*PATHFINDER MINES  
CORPORATION  
SHIRLEY BASIN MINE*

*TAILINGS RECLAMATION  
PLAN*

**RE: Docket No. 40-6622, Source Material License SUA-442  
Pathfinder Shirley Basin Tailings Reclamation**

RE: RESPONSE TO N.R.C. STAFF REVIEW COMMENTS  
PATHFINDER MINES CORPORATION RECLAMATION PLAN  
SHIRLEY BASIN URANIUM MILL SITE  
SHIRLEY BASIN, WYOMING

Slip Surface Option Grid and Radius

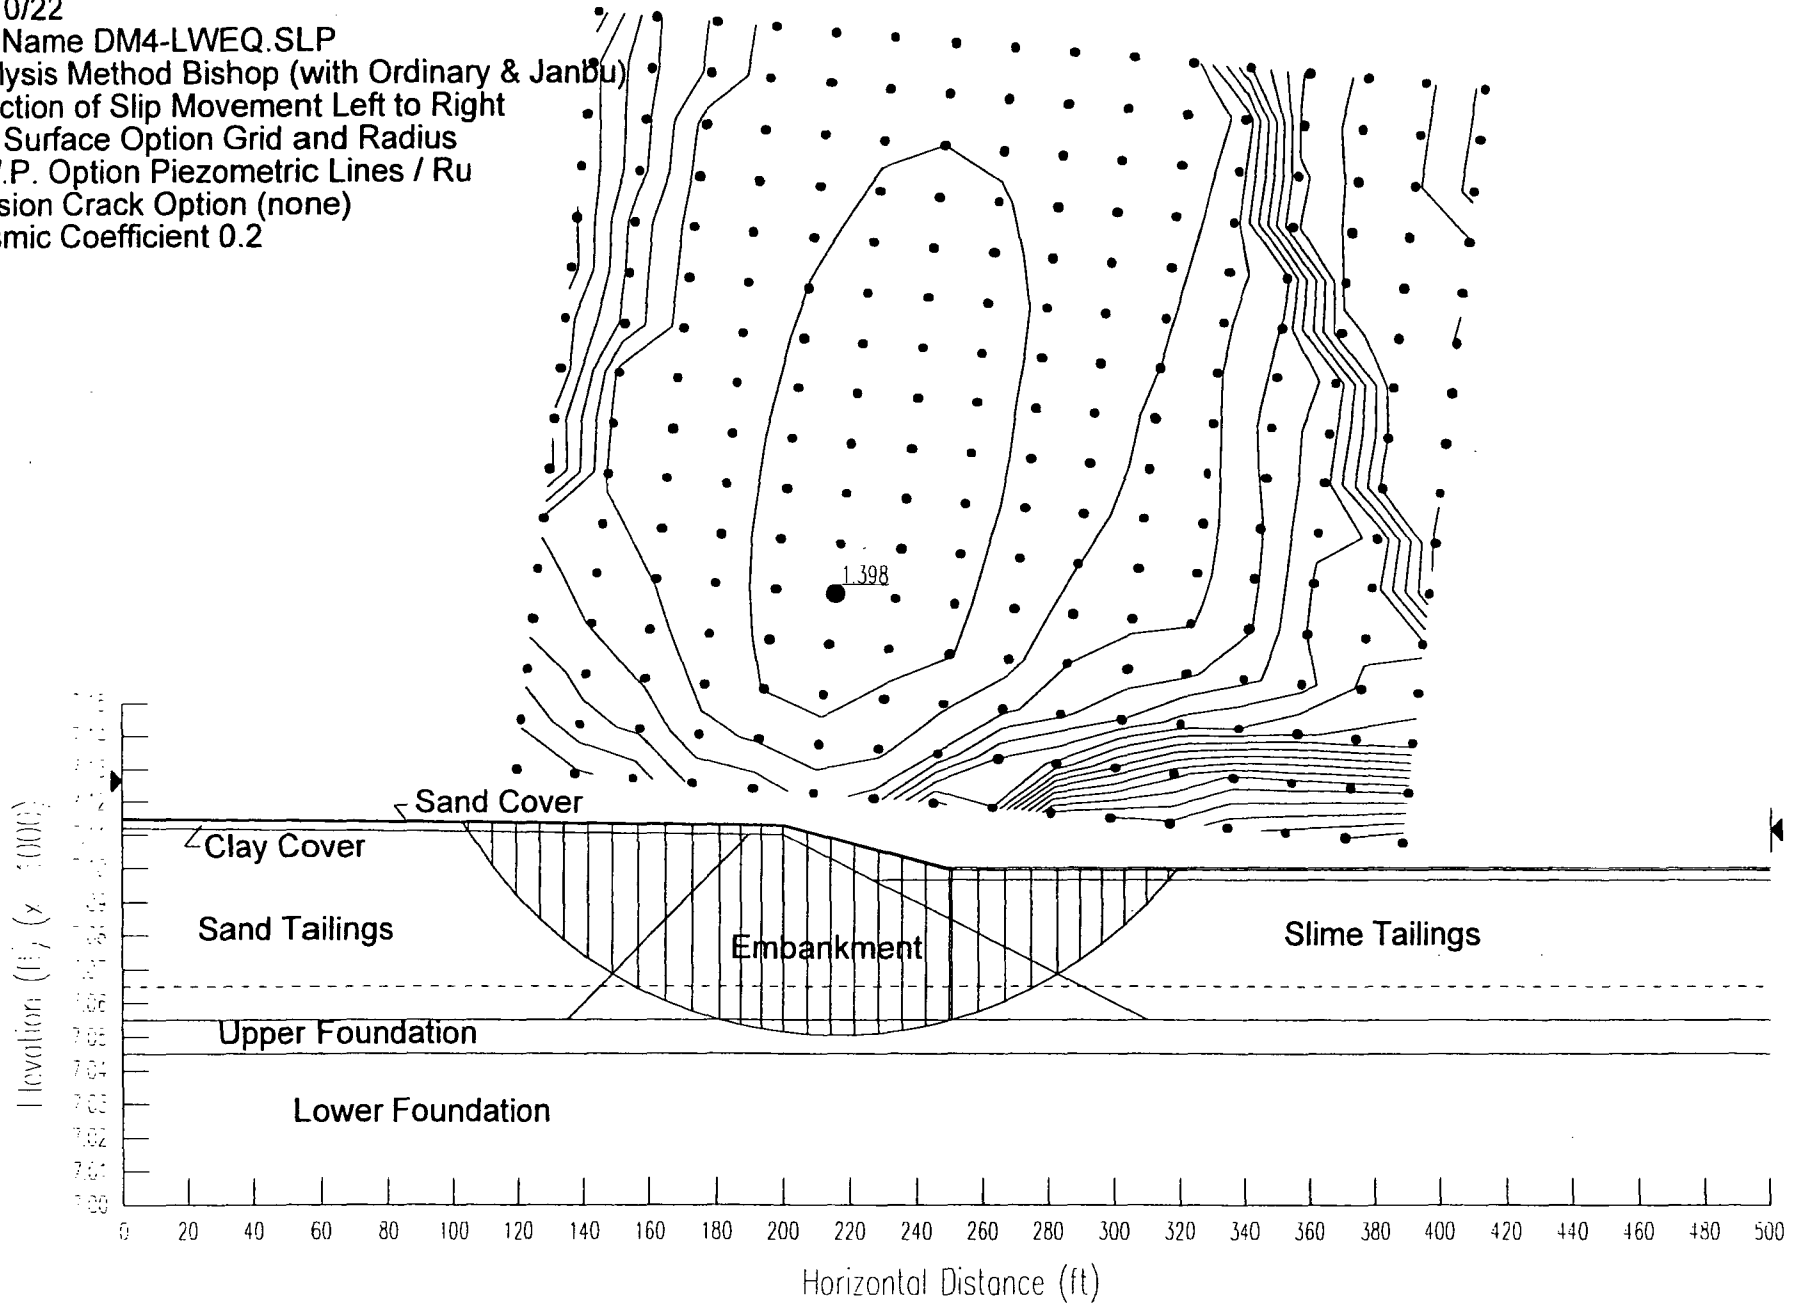
This letter summarizes our response to the NRC's staff review comments (items No. 1 and 2) regarding the slope stability and liquefaction potential analyses for Dams No. 4 and 5 at the above-referenced project. The NRC is requesting additional information regarding: 1) documentation of soil parameters used in the slope stability analyses, and 2) additional consideration of the methodologies used in the stability analyses. More specifically, an evaluation of the stability analyses is requested regarding: i) the effects of variations associated with the geometry of the slopes, soil and rock parameters, and pore pressures acting within the slopes, and ii) effects of the assumptions inherent in the Modified Bishop's Method. In addition, further discussion of the liquefaction potential and the selection of soil parameters related to: i) material strength loss, and ii) pore pressure development due to dynamic loads.

shear strength of the clayey foundation soils. In light of this, Dam No. 4 was reanalyzed for the purpose of this response using the foundation soils from Dam No. 5. The results of the analysis are tabulated below, and plots of the analyses are enclosed.

In order to evaluate the conservative nature of variations in soil parameters, it is important to consider the results of the modified Dam No. 4 analysis discussed previously. Since the shear strength of sandy soils is less than the clayey soils, using the sandy foundation soils would result in the most conservative results. The Dames and Moore reports state that in the original design for Dam No. 5 the maximum shear strength of the sandy foundation soils is 4900 psf. However, from the original analysis of Dam No. 4, it can be observed that the bottom of failure surface for the high water seismic analysis is tangent to an elevation at approximately 7050. Shear strength at this depth is approximately 1300 psf. Any variations of soil parameters resulting in a shear strength greater than 1300 psf would exhibit conservative results.

Variations in geometry for Dam No. 4 would not effect stability analyses significantly because the critical failure surfaces are controlled by the shear strength of the foundation soils. However, variations in the geometry for Dam No. 5 would affect stability results. The stability analysis for Dam No. 5 was performed on the maximum cross-section. The most critical failure condition occurs at high water conditions under seismic loading. Additional stability analysis event at a downstream slope of 3:1 instead of the previously analyzed 4:1 slope, results in minimum factor of safety of 1.10. Additionally, we understand that the final reclamation plan, as currently being revised, flattens the down stream slope to 5:1 which would result in more conservative results than the 3:1 and 4:1 analyzed slopes.

In our opinion, the modified Bishop's Method yields conservative results for both static and pseudo-static analyses. Due to both embankments being constructed of generally cohesive materials, it is reasonable to assume that a circular failure surface would occur within the embankments. The modified Bishop's Method is based on moment equilibrium. However, it is also useful to evaluate force equilibrium methods to compare the conservatism of the analyses. The most common force equilibrium method is the Janbu Method of analysis. The following tables summarize the minimum factors of safety based on the Janbu Method.
